# Access Audit Site Report

**Martin Creek Lake State Park**

**Accessibility Evaluation**

**Inspection Date: 04/08/2022**

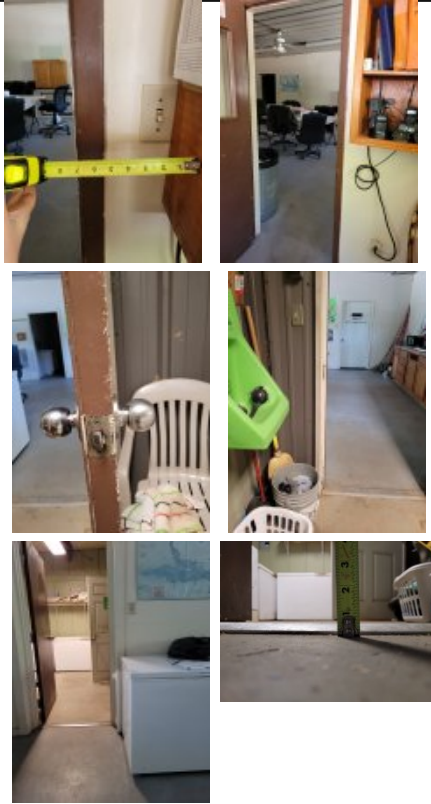
Finding Number	Area Description	Lat/Long	Finding	As Built	Recommendation	Citation	Photos	Figure
1	Employee Areas: Maintenance	[32.2768919 , -94.564799 2]	Spaces and elements within employee work areas shall only be required to comply with 206.2.8, 207.1, and 215.3 and shall be designed and constructed so that individuals with disabilities can approach, enter, and exit the employee work area. Employee work areas, or portions of employee work areas, other than raised courtroom stations, that are less than 300 square feet (28 m2) and elevated 7 inches (180 mm) or more above the finish floor or ground where the elevation is essential to the function of the space shall not be required to comply with these requirements or to be on an accessible route.	laundry door - 14" clearance push side, storage blocks pull side, knob hardware	For employee spaces, relocate storage, furniture, and other obstacles at doorways to provide approach, enter and exit at the employee space. Provide required maneuvering clearance on push and pull side of doors. Replace hardware with lever hardware or hardware operable without a tight pinch or grasp.	2015 ABAAS Section: F203.9 2012 TAS Section: 203.9 2010 ADAS Section: 203.9

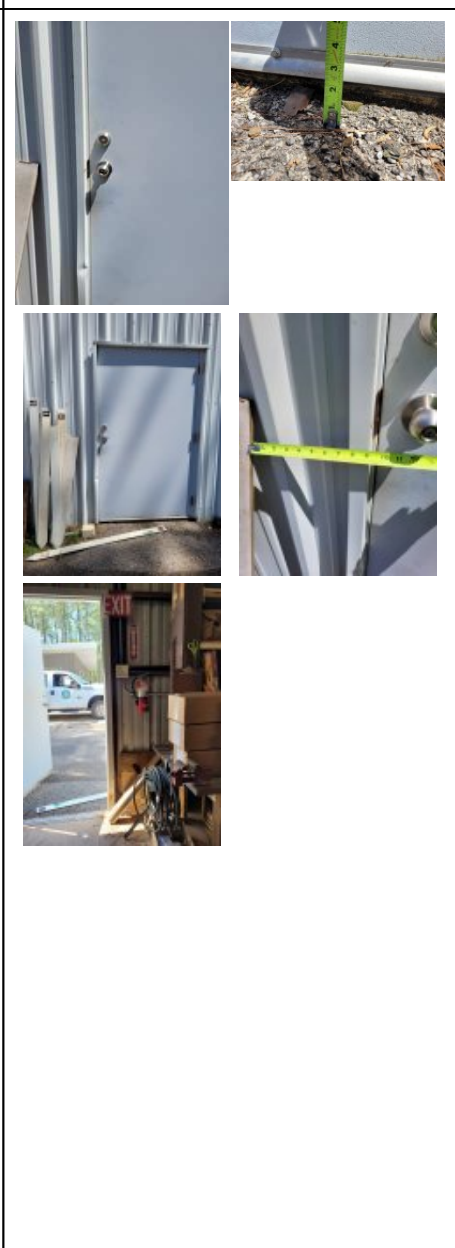
Finding Number	Area Description	Lat/Long	Finding	As Built	Recommendation	Citation	Photos	Figure
2	Employee Areas: Maintenance	[32.2770313 , -94.564531]	Spaces and elements within employee work areas shall only be required to comply with 206.2.8, 207.1, and 215.3 and shall be designed and constructed so that individuals with disabilities can approach, enter, and exit the employee work area. Employee work areas, or portions of employee work areas, other than raised courtroom stations, that are less than 300 square feet (28 m2) and elevated 7 inches (180 mm) or more above the finish floor or ground where the elevation is essential to the function of the space shall not be required to comply with these requirements or to be on an accessible route.	Lacks AR to car port, white shed in lot, and tractor Blue small building - 17" CIL, knob, 31" width	For employee spaces, relocate storage, furniture, and other obstacles at doorways to provide approach, enter and exit at the employee space. Create an accessible route with crushed stone or other outdoor material from parking or walkway to car port, white shed in lot, and tractor. Replace doors with doors having 80" overhead clearance and 32" clear width. Repair, bevel, or ramp CILs at door entries to max .25". Replace hardware with lever hardware or hardware operable without a tight pinch or grasp.	2015 ABAAS Section: F203.9 2012 TAS Section: 203.9 2010 ADAS Section: 203.9

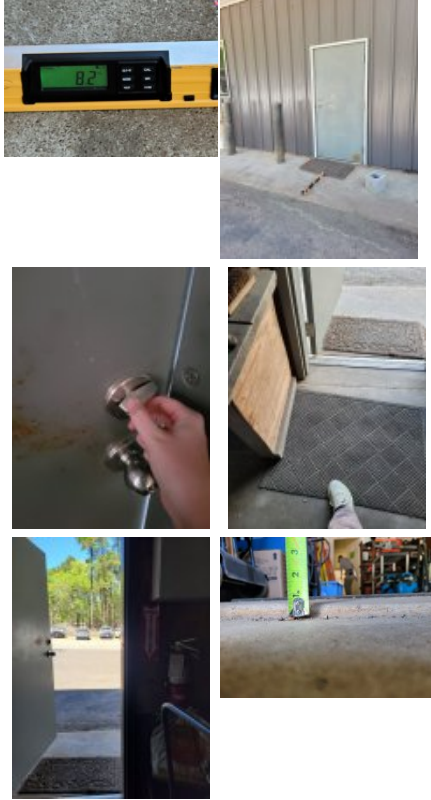
Finding Number	Area Description	Lat/Long	Finding	As Built	Recommendation	Citation	Photos	Figure
7	Employee Areas: Maintenance	[32.2768941, -94.5648086]	The there is no lower drinking fountain meeting the requirements for persons using wheelchairs. Spout outlets of the lower bowl drinking fountains shall be 36 inches maximum above the finish floor or ground. Lower bowl drinking fountains shall provide knee and toe clearance centered on the unit.	Lacks low bowl fountain	Add second low bowl fountain for persons using wheelchairs.	2015 ABAAS Section: 602.4 2012 TAS Section: 602.4 2010 ADAS Section: 211.2		
8	Employee Areas: Maintenance	[32.2768885, -94.5648006]	Spaces and elements within employee work areas shall only be required to comply with 206.2.8, 207.1, and 215.3 and shall be designed and constructed so that individuals with disabilities can approach, enter, and exit the employee work area. Employee work areas, or portions of employee work areas, other than raised courtroom stations, that are less than 300 square feet (28 m2) and elevated 7 inches (180 mm) or more above the finish floor or ground where the elevation is essential to the function of the space shall not be required to comply with these requirements or to be on an accessible route.	Ice room - 10" clearance on push side due to fountain, knob Office by entry - clearance on push side reduced to 2" by storage, window 47.5" AFF, knob, 7" clearance due to shelf Laundry door from kitchen - knob, clearance on pull side reduced by storage, clearance on push push reduced by freezer, 1" CIL at threshold	For employee spaces, relocate storage, furniture, and other obstacles at doorways to provide approach, enter and exit at the employee space. Provide required maneuvering clearance on push and pull side of doors. Repair, bevel, or ramp CILs at door entries to max .25". Replace hardware with lever hardware or hardware operable without a tight pinch or grasp. Replace doors with ones having sidelight viewing windows max 43" AFF.	2015 ABAAS Section: F203.9 2012 TAS Section: 203.9 2010 ADAS Section: 203.9

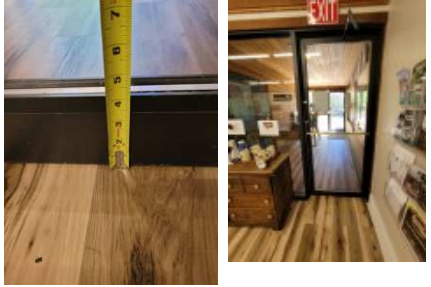
Finding Number	Area Description	Lat/Long	Finding	As Built	Recommendation	Citation	Photos	Figure
12	Employee Areas: Residences	[32.2783477 , -94.564844 8]	The walkway contains abrupt vertical edges and/or variations over a 1/4 inch. 1/4 inch is the maximum vertical rise. Changes in level between 1/4 inch and 1/2 inch must be beveled at 1:2 or less. Changes in level greater than 1/2 inch must be by way of a ramp.	steps to enter residence	For changes in level 6" or greater, provide a ramp for access.	2012 TAS Section: 303.2, 303.3  2010 ADAS Section: 303.2, 303.3

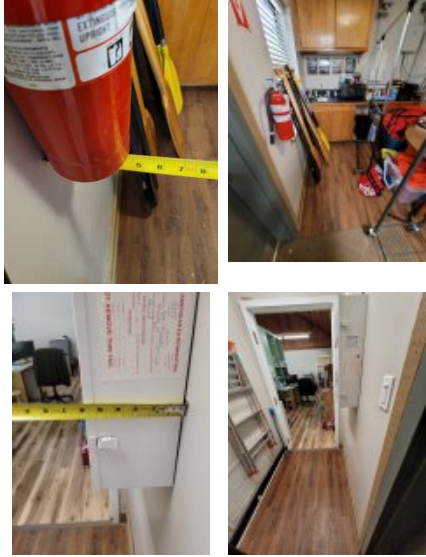
Finding Number	Area Description	Lat/Long	Finding	As Built	Recommendation	Citation	Photos	Figure
25	Headquarters Area: HQ Public Spaces	[32.2778624 , -94.5659204]	The 30 inches minimum by 48 inches minimum clear floor space required at the operable part is not flat (2% or 1:48 maximum slope) in all directions. Changes in level are not permitted at required clear floor or ground space except that slopes not steeper than 1:48 shall be permitted.	7.5% slope in CFS for sign	Correct or repair slope in CFS to max 2.08%.	2015 ABAAS Section: 305.2 2012 TAS Section: 305.2 2010 ADAS Section: 305.2		
26	Headquarters Area: HQ Public Spaces	[32.2780042 , -94.5660264]	The operable part is not accessible because there is not adequate clear floor space for either a forward or side approach. The clear floor or ground space shall be 30 inches minimum by 48 inches minimum.	Ice cooler lacks CFS - 27"	Provide required 30" by 48" CFS at operable parts.	2015 ABAAS Section: 305.3 2012 TAS Section: 305.3 2010 ADAS Section: 305.3

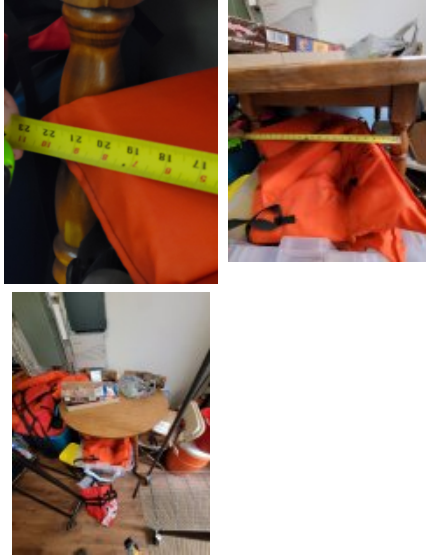
Finding Number	Area Description	Lat/Long	Finding	As Built	Recommendation	Citation	Photos	Figure
27	Headquarters Area: HQ Public Spaces	[32.2778659 , -94.566025] [32.2779089 , -94.5659915]	There is a gap spaced greater than a 1/2 inch. Openings in floor or ground surfaces shall not allow passage of a sphere more than 1/2 inch diameter. Elongated openings shall be placed so that the long dimension is perpendicular to the dominant direction of travel.	Gaps of 1.25" at corner by table, 4.5" on path from access aisle at parking to table, 1" along walkway	Correct or fill gaps to be max .5".	2015 ABAAS Section: 302.3  2012 TAS Section: 302.3  2010 ADAS Section: 302.3

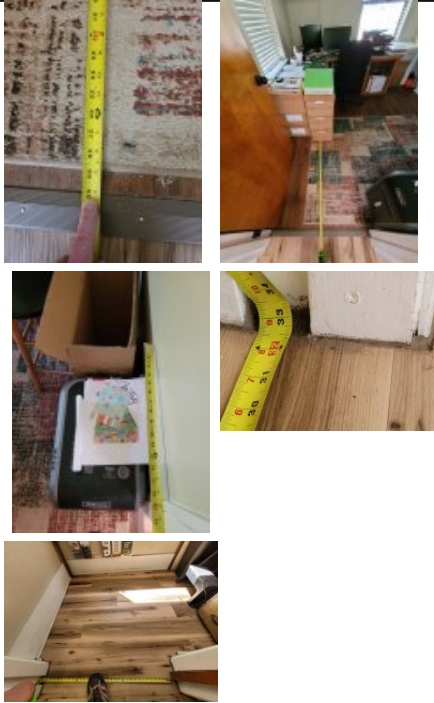
33	Headquarters Area: HQ Employee Spaces	[32.278003, -94.5660197]	There is insufficient turning space within this room or space. The space required for a wheelchair to make a 180-degree turn is a clear space of 60 inches in diameter or a T-shaped space.	break area- lacks turning space due to storage	Relocate obstacles to create turning space in room.	2015 ABAAS Section: 304.3.1, 304.3.2 2012 TAS Section: 304.3.1, 304.3.2 2010 ADAS Section: 304.3.1, 304.3.2

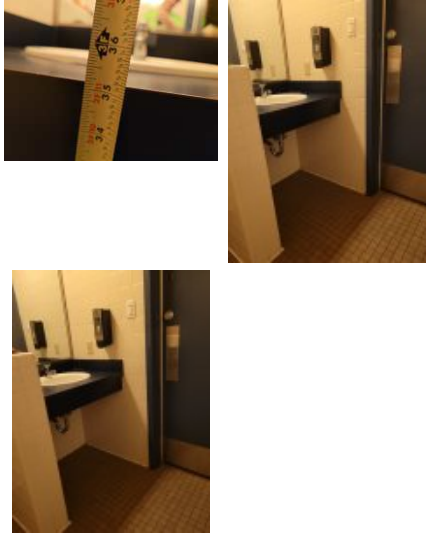
Finding Number	Area Description	Lat/Long	Finding	As Built	Recommendation	Citation	Photos	Figure
39	Headquarters Area: HQ Employee Spaces	[32.2780019 , -94.566025]	Employee Work Areas. Common use circulation paths within employee work areas shall comply with 402. EXCEPTIONS: 1. Common use circulation paths located within employee work areas that are less than 1000 square feet (93 m2) and defined by permanently installed partitions, counters, casework, or furnishings shall not be required to comply with 402. 2. Common use circulation paths located within employee work areas that are an integral component of work area equipment shall not be required to comply with 402. 3. Common use circulation paths located within exterior employee work areas that are fully exposed to the weather shall not be required to comply with 402.	Right office - 28" wide route	Make corrections for compliant circulation path.	2015 ABAAS Section: F206.2.8, F206.2.8.1, F206.2.8.2  2012 TAS Section: 206.2.8, 206.2.8 Exception 1, 206.2.8 Exception 2, 206.2.8 Exception 3, 206.2.8 Advisory 1, 206.2.8 Advisory 2  2010 ADAS Section: 206.2.8, 206.2.8 Exception 1, 206.2.8 Exception 2, 206.2.8 Exception 3

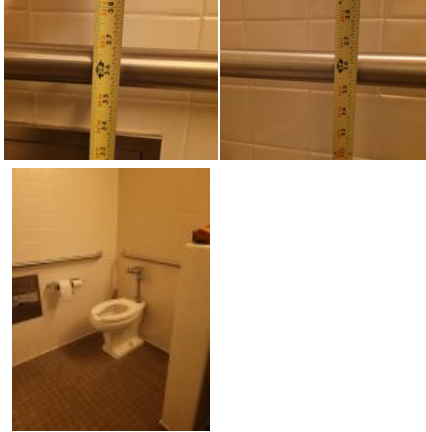
42	Headquarters Area: HQ Men's Restroom	[32.2779849 , -94.5660277]	The top rim of the sink is too high. All lavatories/sinks that are designated to be accessible shall be a minimum 17 inches in horizontal depth and mounted with the rim or counter edge no higher than 34 inches above the finished floor.	Sink rim at 35.25" AFF	Lower sinks to max 34" above the finished floor (AFF) to front of rim.	2015 ABAAS Section: 606.3  2012 TAS Section: 606.3  2010 ADAS Section: 606.3

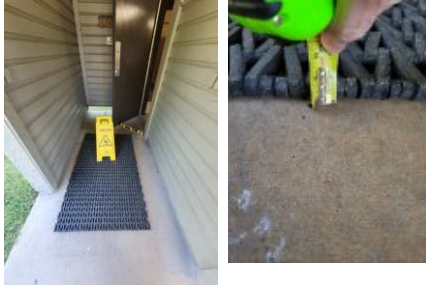
89	Day Use Area: Day Use - Swim Area Women's Restroom	[32.275199, -94.565911]	The water and drain pipes under the lavatory are not adequately insulated. Water supply and drain pipes under lavatories and sinks shall be insulated or otherwise configured to protect against contact. There shall be no sharp or abrasive surfaces under lavatories and sinks.	Sinks lack insulated pipes	Insulate exposed pipes under one sink.	2015 ABAAS Section: 606.5  2012 TAS Section: 606.5  2010 ADAS Section: 606.5

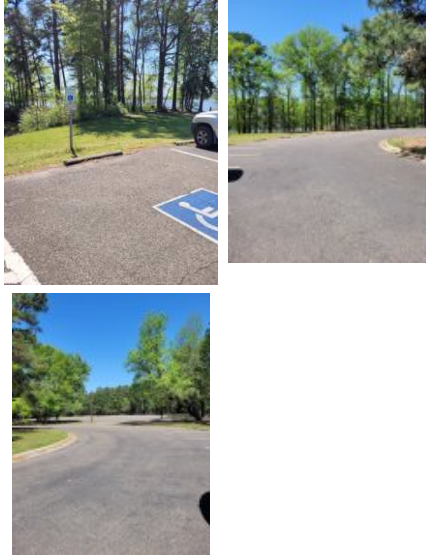
100	Day Use Area: Day Use - Swim Area Women's Restroom	[32.2751956 , -94.565915]	The floor mat or carpet pile height is too high. The doormat is not secured in place at the entry door. Carpet or carpet tile shall be securely attached and shall have a firm cushion, pad, or backing or no cushion or pad. Carpet or carpet tile shall have a level loop, textured loop, level cut pile, or level cut/uncut pile texture. Pile height shall be 1/2 inch maximum. Exposed edges of carpet shall be fastened to floor surfaces and shall have trim on the entire length of the exposed edge.	unsecured floor mat, .5" pile	Replace mat or carpet with one having max pile or edge of 1/4". Remove or secure mat at door to prevent trip hazard.	2015 ABAAS Section: 302.2  2012 TAS Section: 302.2  2010 ADAS Section: 302.2		
101	Day Use Area: Day Use - Parking	[32.2749631 , -94.566084]	Element meets all standards and requirements	Day use area parking meets scoping requirements - 23 standard, 2 accessible	None	2010 ADAS Section: N/A

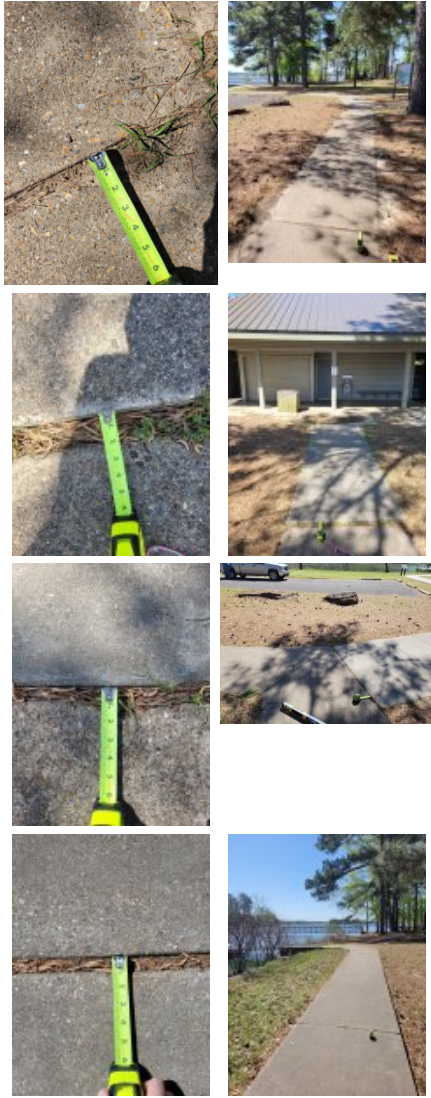
118	Day Use Area: Day Use - Playground	[32.2746116 , -94.566776]	Element meets all standards and requirements	4 swings (2 basket, 2 belt) comply with correction to surface	None	2010 ADAS Section: N/A																																																
119	Day Use Area: Day Use - Playground	[32.2746184 , -94.566774 7]	There are not enough accessible ground level play components based on the number of elevated play components. There should be a minimum of 2 accessible ground level play components of 2 types	fails to meet incentive scoping, requires 2 of 2 types, only 1 type provided (swings)	Add one more GLPC of type other than swings to meet incentive scoping	2012 TAS Section: 240.2.1.2  2010 ADAS Section: 240.2.1.2

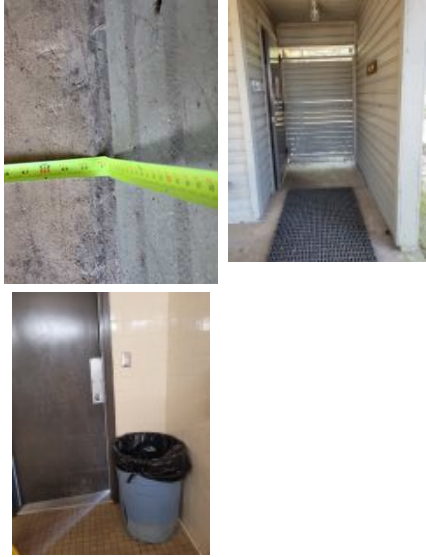
131	Day Use Area: Day Use - Fishing	[32.2719821 , -94.5662128]	Not enough of the railings, guards, or handrails are at the allowable height. At least 25 percent of the railings, guards, or handrails shall be 34 inches maximum above the ground or deck surface.	Railing is 34.5" AFF, two 39" spots on large pier	Lower 25% of the railing; dispersed through pier, to max 34".	2015 ABAAS Section: 1005.2.1  2010 ADAS Section: 1005.2.1

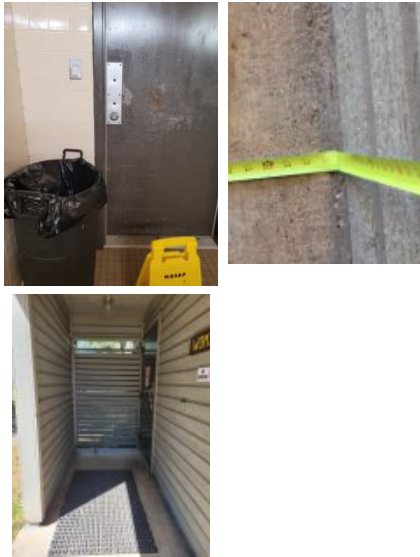
161	Day Use Area: Day Use - Boat Ramp Women's Restroom	[32.27315, -94.56654]	The stall door fails to comply with all of the door requirements. The stall door must be a minimum of 32" wide and have compliant hardware on both sides. The stall door must be self-closing.	Ambulatory stall lacks self-closing door, and hardware requires tight pinch	Adjust stall door to be self-closing. Replace stall hardware with hardware operable without a tight pinch or grasp on both sides of the stall door.	2015 ABAAS Section: 404.2.3, 404.2.7, 604.8.2.2  2012 TAS Section: 404.2.3, 404.2.7, 604.8.2.2  2010 ADAS Section: 404.2.3, 404.2.7, 604.8.2.2

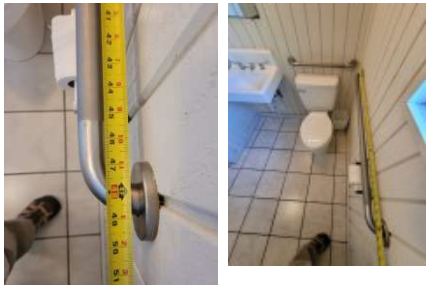
Finding Number	Area Description	Lat/Long	Finding	As Built	Recommendation	Citation	Photos	Figure
172	Day Use Area: Day Use - Tournament Weigh-in Station	[32.2736285 , -94.565955 3]	Picnic tables shall provide at least one wheelchair space for each 24 linear feet (7320 mm) of usable table surface perimeter. Wheelchair spaces shall be 30 inches (760 mm) minimum by 48 inches (1220 mm) minimum. Wheelchair spaces shall be positioned for a forward approach to the table and provide knee and toe clearance complying with 306 under the table	1 of 1 picnic tables are not of an accessible design	Replace picnic table with one of an accessible design as a smart practice.	2015 ABAAS Section: 1011.4.2

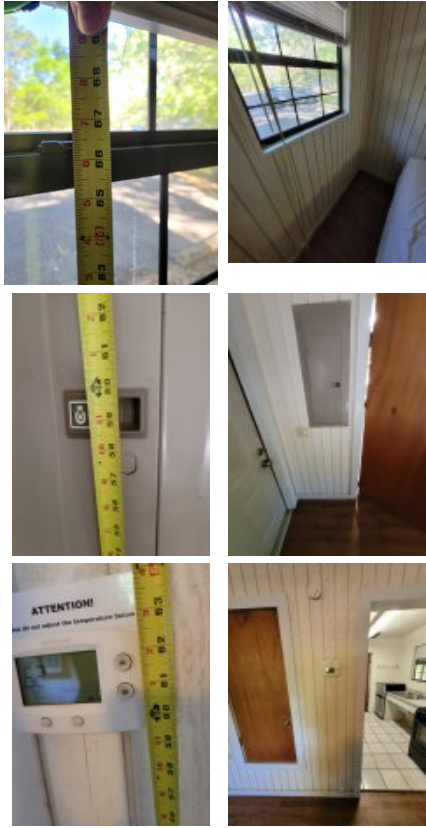
206	Cabins: Cabin 1	[32.2749336, -94.569412 6]	There is a gap spaced greater than a 1/2 inch. Openings in floor or ground surfaces shall not allow passage of a sphere more than 1/2 inch diameter. Elongated openings shall be placed so that the long dimension is perpendicular to the dominant direction of travel.	2" gap at entry to cabin from parking lot	Correct or fill gaps to be max .5".	2015 ABAAS Section: 302.3  2012 TAS Section: 302.3  2010 ADAS Section: 302.3

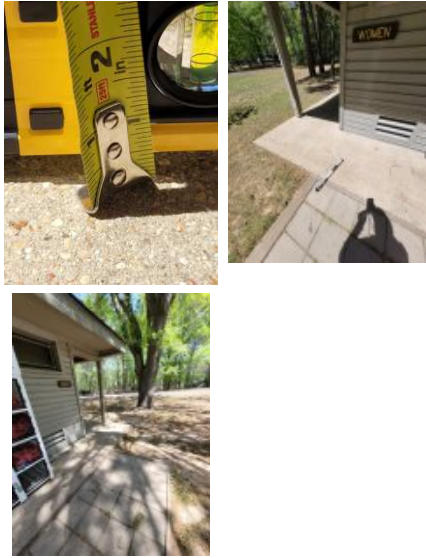
277	Shelter Camping Area: Shelter Camping - Men's Restroom	[32.2735401, -94.569538 7]	The door is equipped with a door closer and returns to a closed position too quickly. Door closers and gate closers shall be adjusted so that from an open position of 90 degrees, the time required to move the door to a position of 12 degrees from the latch is 5 seconds minimum.	Men's restroom door - fast close - 3 seconds	Inspect, adjust, and maintain closing speed on door closers.	2015 ABAAS Section: 404.2.8.1 2012 TAS Section: 404.2.8.1 2010 ADAS Section: 404.2.8.1

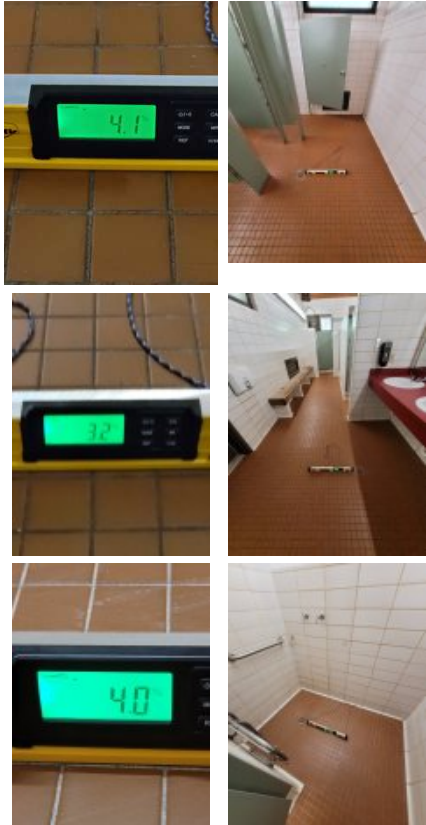
302	Shelter Camping Area: Shelter Camping - Men's Restroom	[32.2735117, -94.569552 1]	The accessible route contains running slopes greater than 5 percent and cross slopes greater than 2 percent across the width of the walk and has not been constructed as a ramp (i.e. handrails, wheel guides, etc.). When the slope in the direction of travel of any walk exceeds 1 unit vertical in 20 units horizontal (5-percent slope), it must be constructed as ramp. Surface cross slopes must not exceed one unit vertical in 48 units. Horizontal (2-percent slope).	3.2% slope at sink floor drain, 4.5% slope toward ambulatory stall, 6% at accessible shower	Correct or repair slope to max 2.08% in restroom.	2015 ABAAS Section: 403.3 2012 TAS Section: 403.3 2010 ADAS Section: 403.3

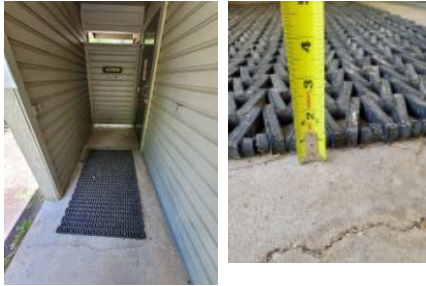
312	Shelter Camping Area: Shelter Camping - Women's Restroom	[32.2735185, -94.569537 4]	The grab bar height and/or spacing fails. Grab bars must be mounted between 33" and 36" to the top of the gripping surface. There must be 1.5" of clearance between the grab bar and the wall. There must be a minimum of 1.5" of clearance below and minimum 12" above the grab bar to any dispenser or other obstruction.	Existing grab bar at 36.25" AFF	Remount grab bars in accessible stall to 33" to 36" above the finished floor (AFF).	2015 ABAAS Section: 609.3, 609.4  2012 TAS Section: 609.4, 609.3  2010 ADAS Section: 609.3, 609.4		
313	Shelter Camping Area: Shelter Camping - Women's Restroom	[32.2735287, -94.569549 4]	The toilet paper is not installed within the compliant range in front of the toilet. Toilet paper dispensers shall be 7 inches minimum and 9 inches maximum in front of the water closet measured to the centerline of the dispenser. The outlet of the dispenser shall be 15 inches minimum and 48 inches maximum above the finish floor and shall not be located behind grab bars. Dispensers shall not be of a type that controls delivery or that does not allow continuous paper flow. There shall be a clearance of 1 1/2 inches minimum below the grab bar.	TP too close to the front of the toilet - 4"	Remount toilet paper dispenser max 7" to 9" from front of toilet, 15" to 48" AFF and min 12" above or 1.5" below grab bar.	2015 ABAAS Section: 604.7  2012 TAS Section: 604.7  2010 ADAS Section: 604.7

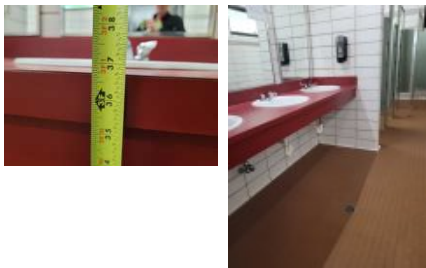
359	Bee Tree Camping Area: Bee Tree - Men's Restroom	[32.2758305 , -94.5723765]	The toilet paper is not installed within the compliant range in front of the toilet. Toilet paper dispensers shall be 7 inches minimum and 9 inches maximum in front of the water closet measured to the centerline of the dispenser. The outlet of the dispenser shall be 15 inches minimum and 48 inches maximum above the finish floor and shall not be located behind grab bars. Dispensers shall not be of a type that controls delivery or that does not allow continuous paper flow. There shall be a clearance of 1 1/2 inches minimum below the grab bar.	TP too close to front of toilet	Remount toilet paper dispenser max 7" to 9" from front of toilet, 15" to 48" AFF and min 12" above or 1.5" below grab bar.	2015 ABAAS Section: 604.7  2012 TAS Section: 604.7  2010 ADAS Section: 604.7
